1. Experts Details & Qualifications

I have been instructed by Allens on behalf of Hancock Coal Pty Ltd to formulate a response to the issues raised in Dr Webb's Additional Statement (the affidavit of Sean Patrick Ryan dated 23 September 2013).

Figure 1 Model recharge area (red area of 400 km²)

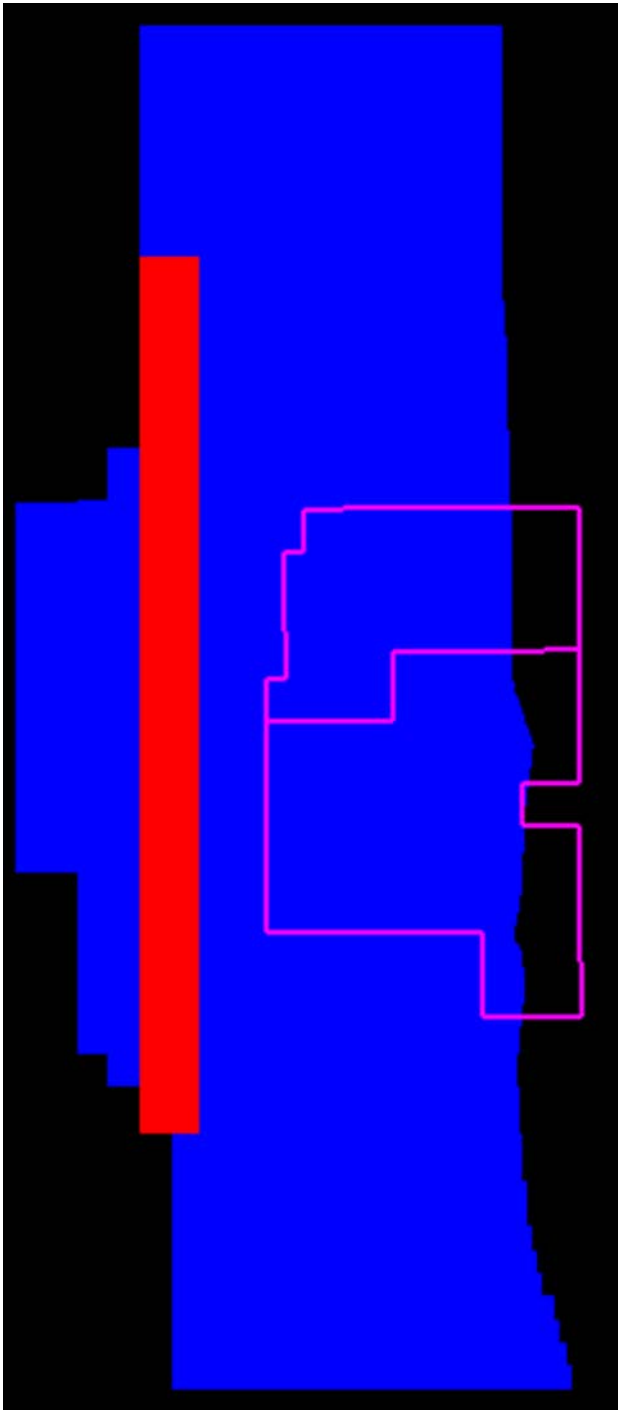
- Direct recharge introduced into the confined Permian C-D sandstone unit;
- Simulate a recharge zone of 400 km² (Figure 1 below). The recharge zone along the Great Dividing Range and size is as envisaged by Dr Webb in his expert's report;

Table 4 Model revised to highest measured C-D and D-E sandstone data – statistics¹

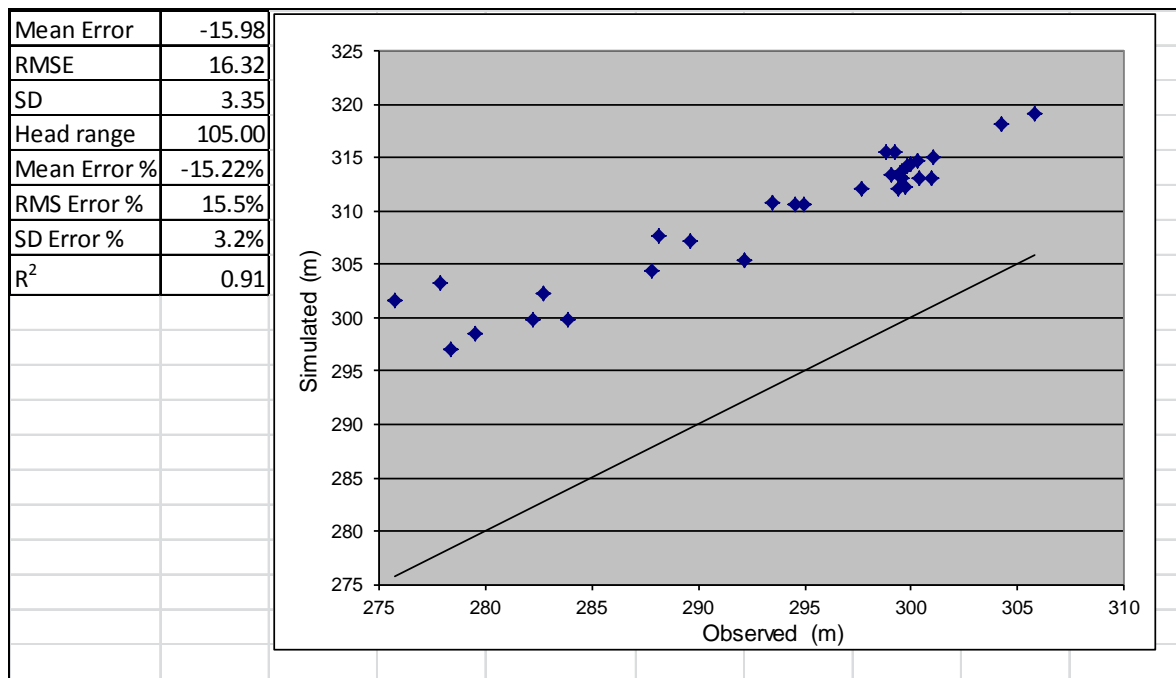
The simulated groundwater heads in the revised model were some 10 to 20 m higher than those measured on site in the various model layers (Table 3). The scaled RMS error, used to assess calibration, was 15.5%. This is outside the adopted calibration RMS error of 5% (Table 4).

Table 5 Model revised to 10 x highest measured C-D and D-E sandstone data – statistics

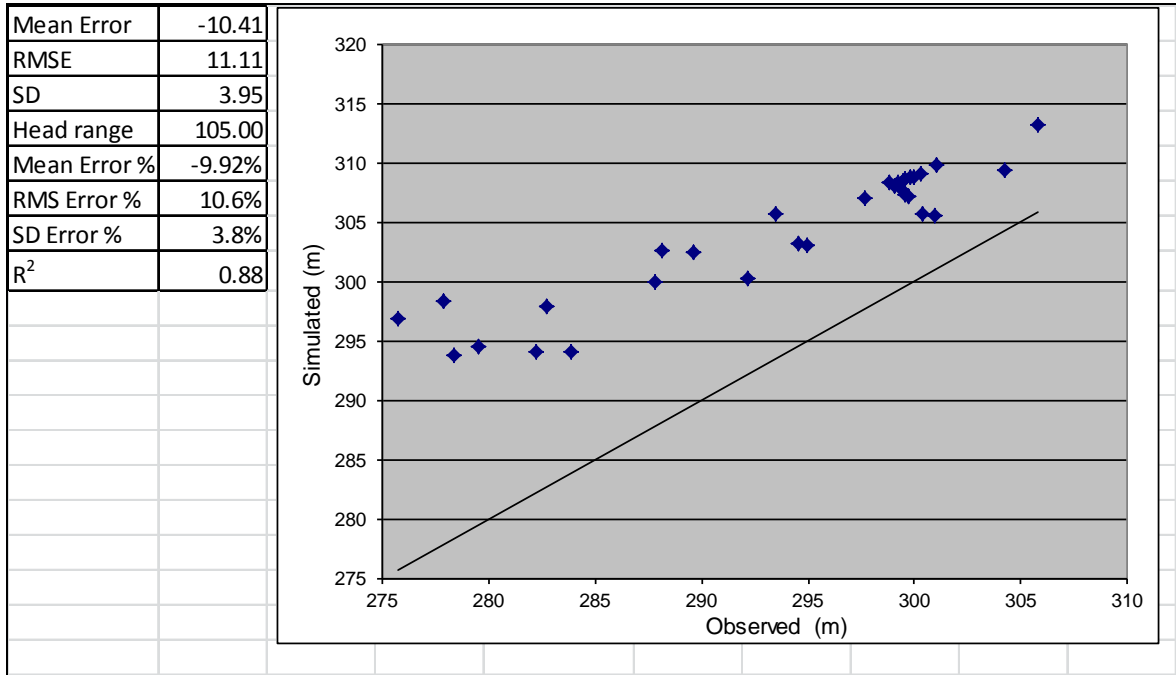
These hydraulic conductivity values are outside of any results measured on site and only conducted to emphasise that for higher recharge, higher hydraulic conductivity values would be required to reduce the modelled groundwater heads. The modelled groundwater heads, in both cases, were still some 10 m above the field measurements and the calibration statistics indicate the RMS error% of ~ 10%, outside the target 5% RMS error.

Table 5 presents the statistics for including hydraulic conductivity values in the C-D, D-E, and sub-E sandstone units that are ten (10) times the highest hydraulic conductivity recorded on site. Table 6 presents the statistics for the twenty (20) times the highest hydraulic conductivity values in the C-D, D-E, and sub-E sandstone units.

Table 8 Transient model with highest measured C-D and D-E sandstone data – statistics

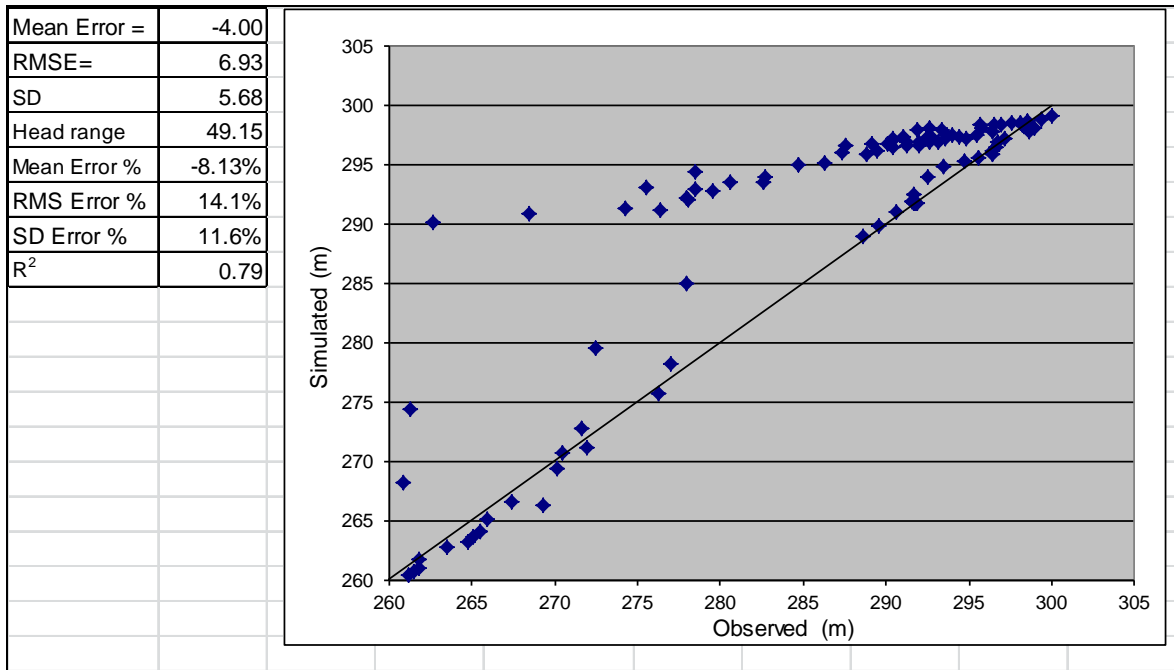
The resultant calibration statistics for the transient model calibration indicates a RMS error of 14.1%, outside of the targeted 5% RMS error. The calibration results are included in Table 8.

The resultant water balance for the revised model indicates a total of 99 ML would be extracted due to the higher permeability values. This is double the 45 ML recorded during the actual Alpha Test Pit dewatering program. The higher hydraulic conductivity values, considering that the Alpha Test Pit allowed for a large 300 m x 250 m excavation, are not representative of site conditions.
